PLAN OF PROPOSED IMPROVEMENT

145 W. WILSON STREET

CITY PROJECT NO. 13759
CONTRACT NO. 9062

ADDENDUM & REVISION HISTORY

| STREET PLAN & PROFILE 145 W. WILSON ST | | | |

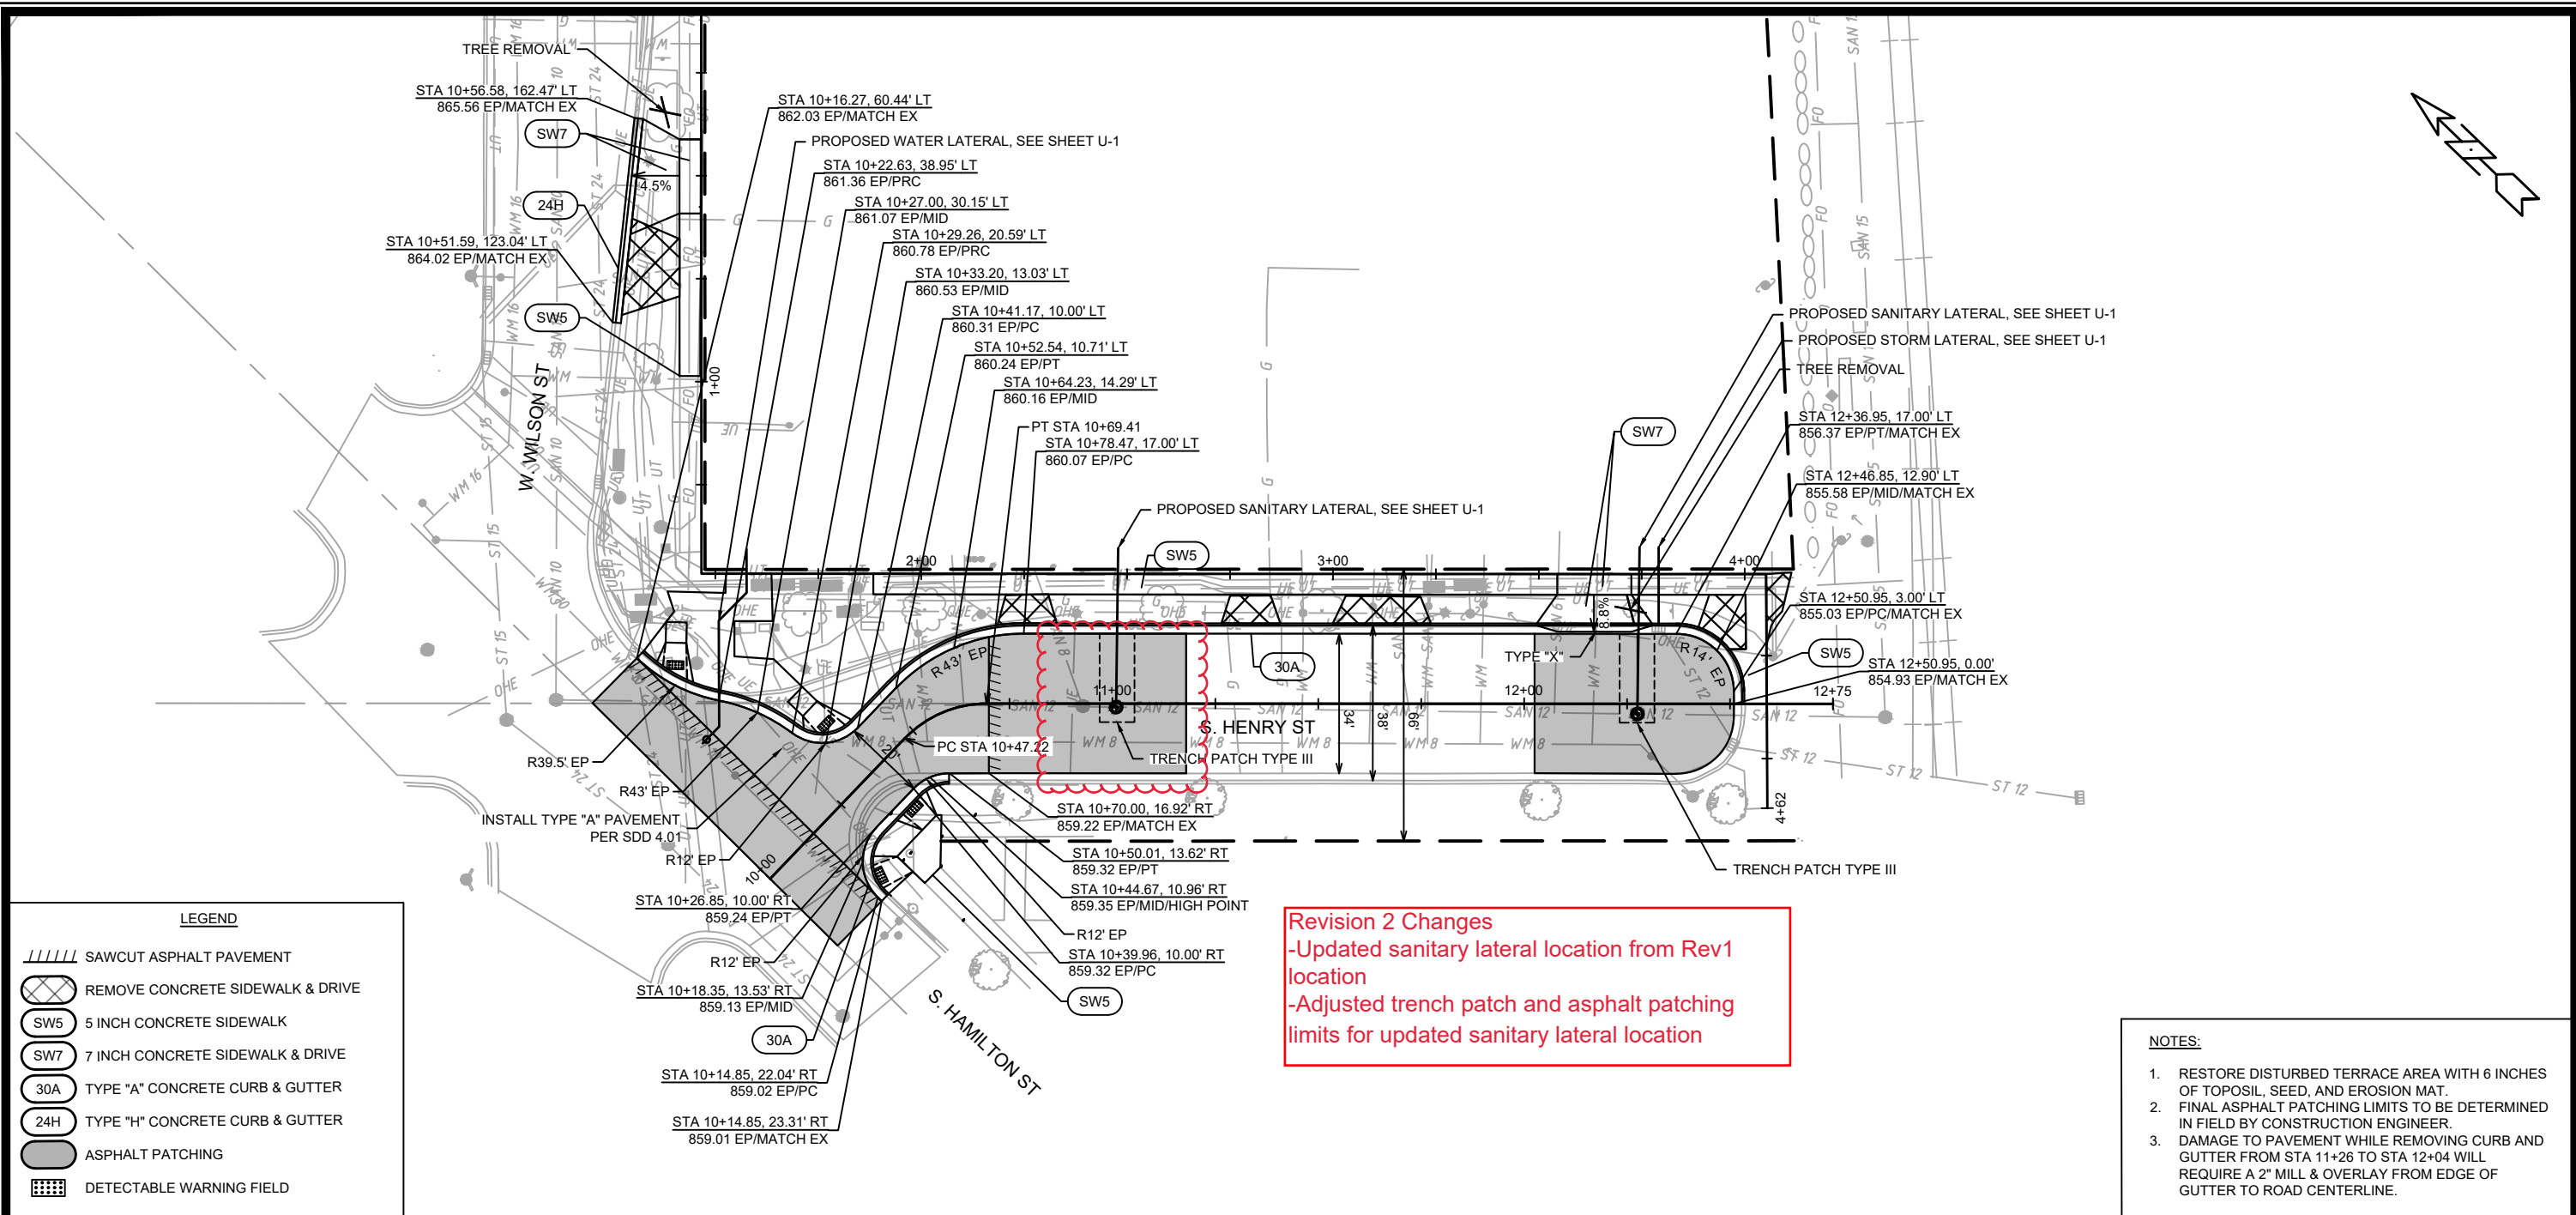
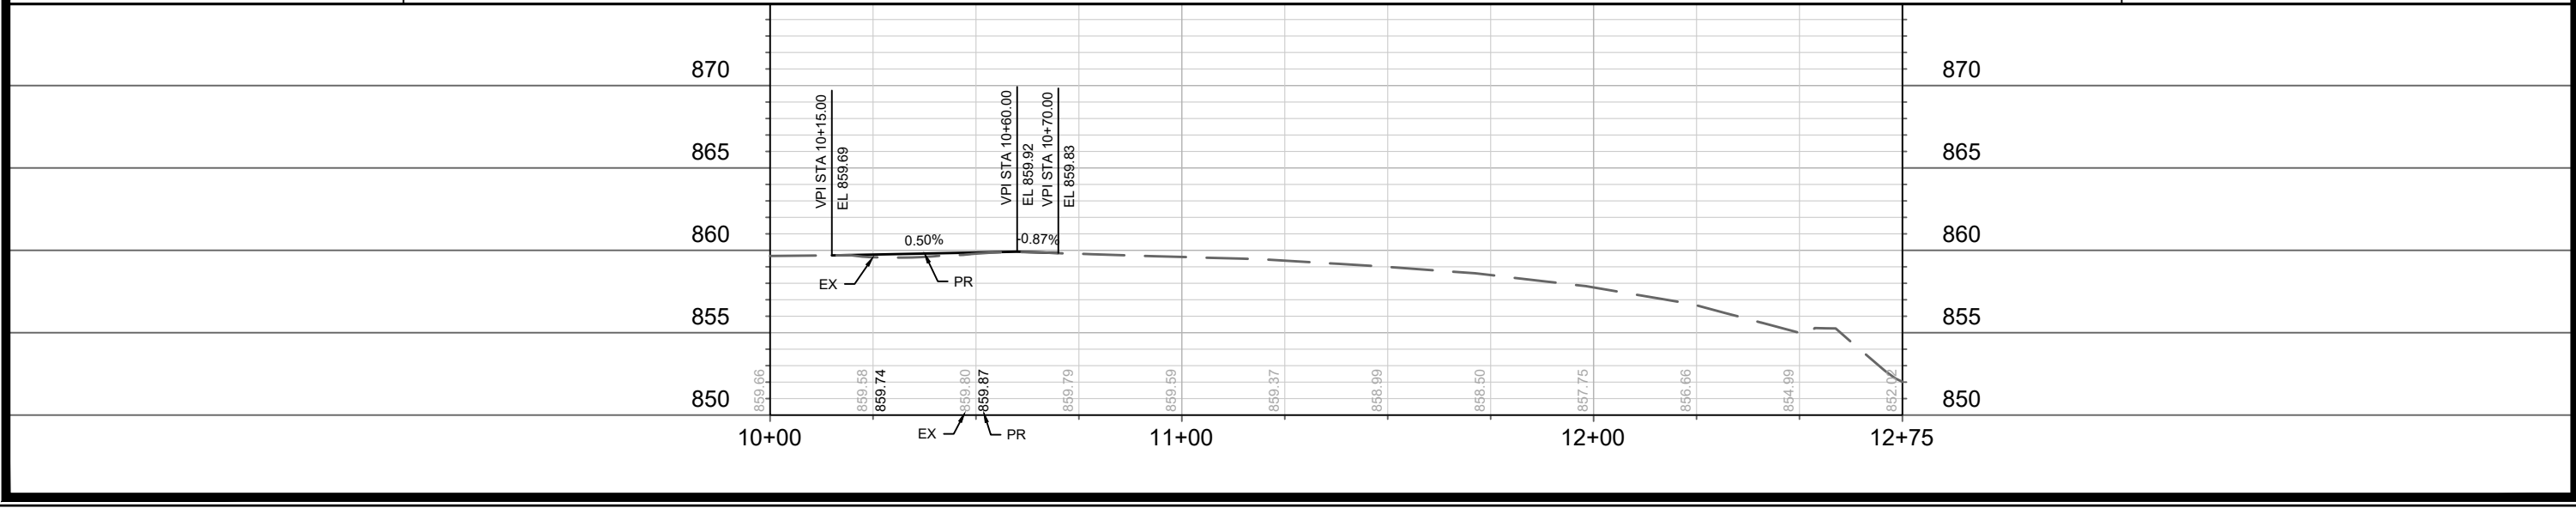
Revision 2 Changes
 -Updated sanitary lateral location from Rev1 location
 -Adjusted trench patch and asphalt patching limits for updated sanitary lateral location

| 13759 P-2 | | | |

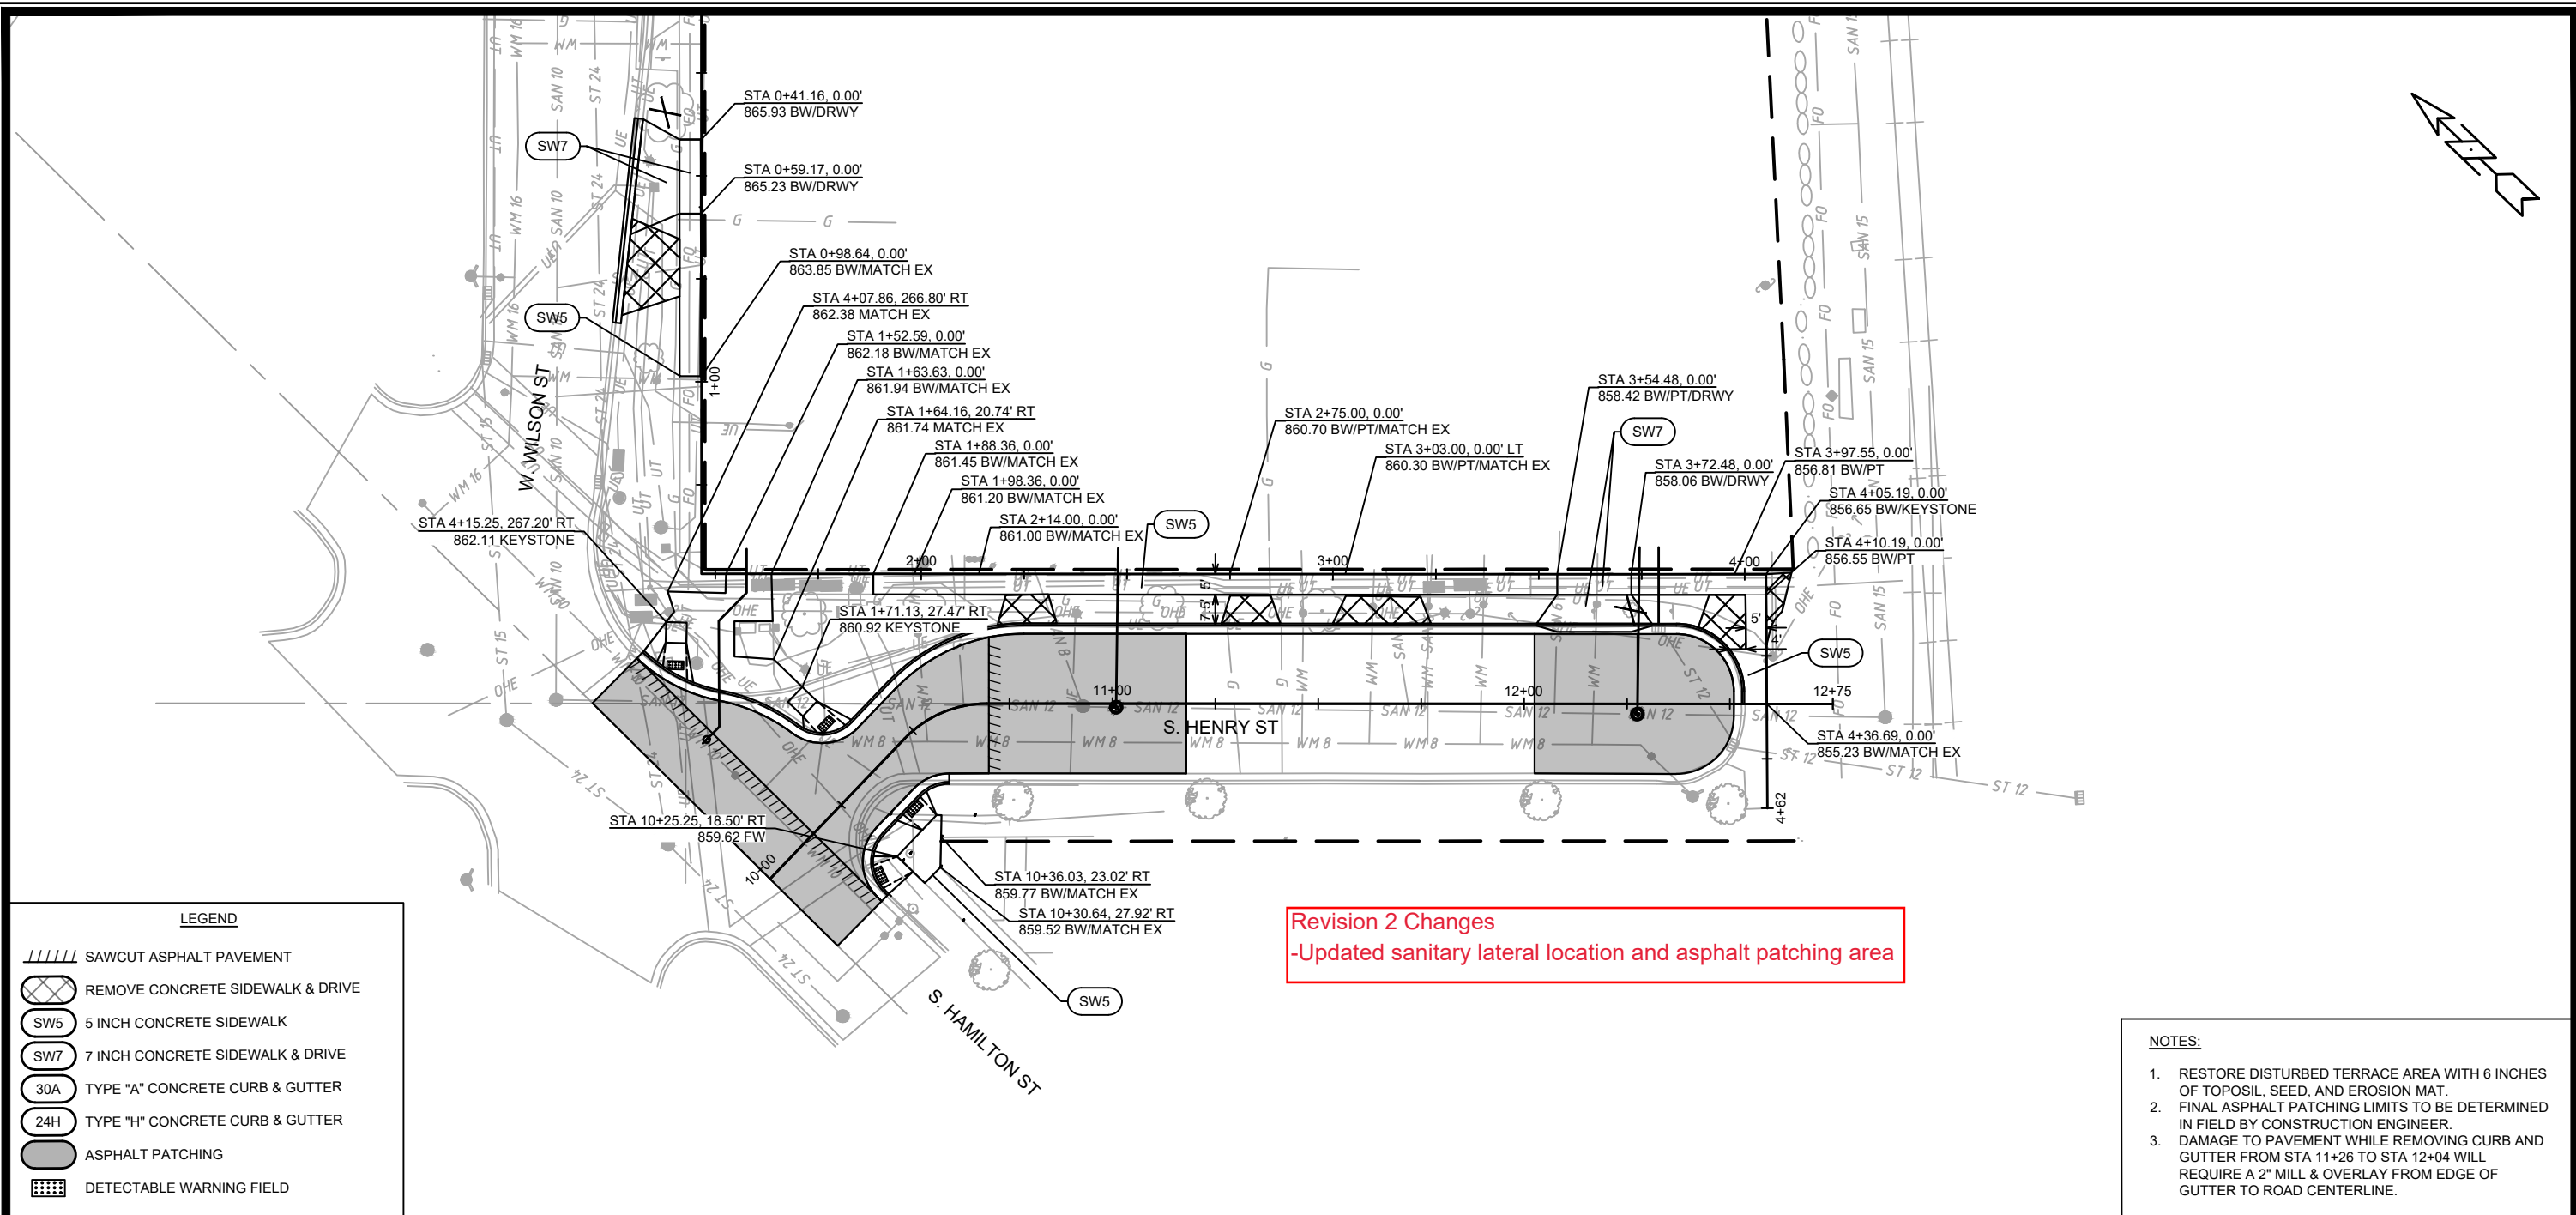
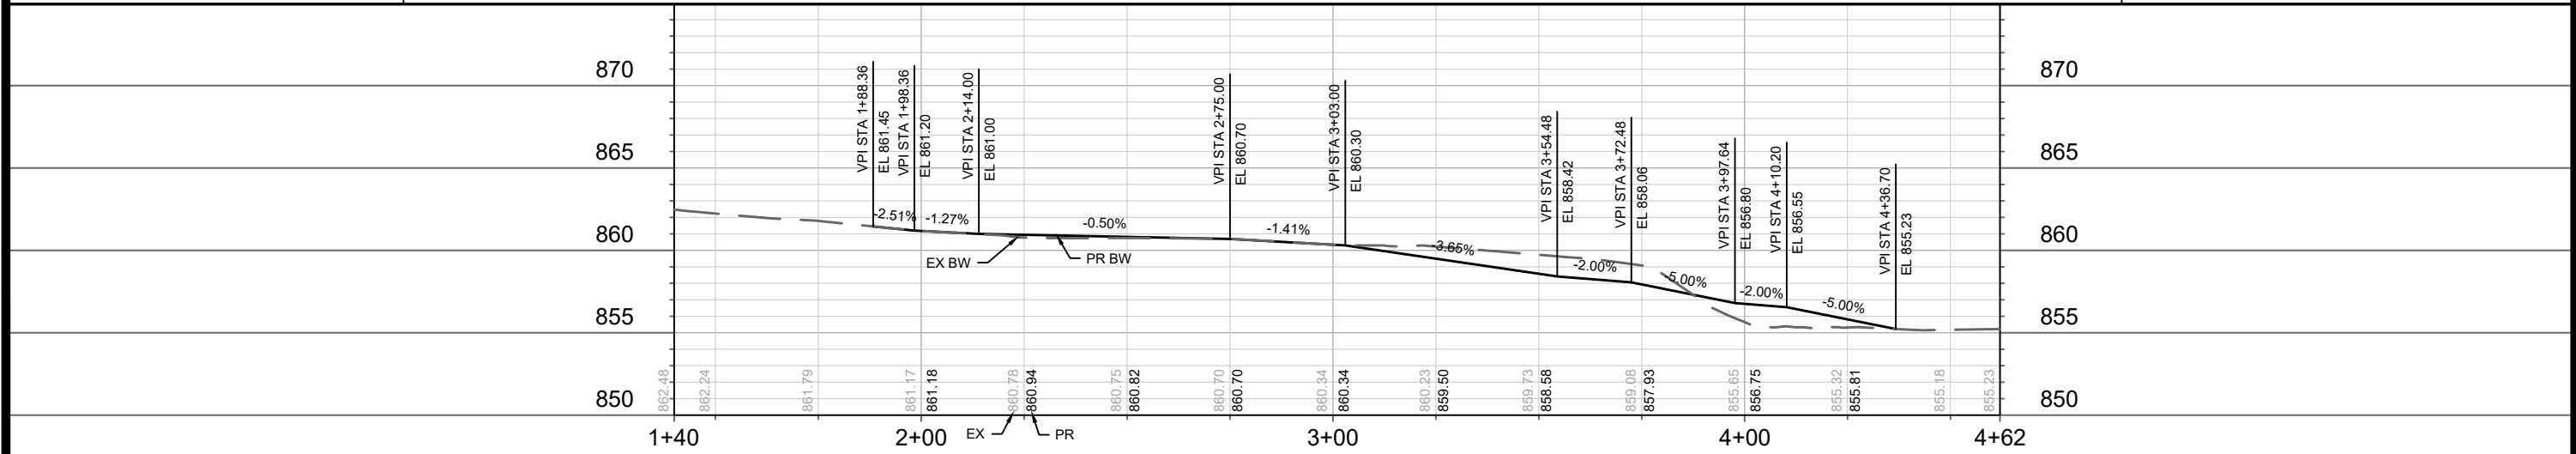
Revision 2 Changes
-Updated sanitary lateral location and asphalt patching area
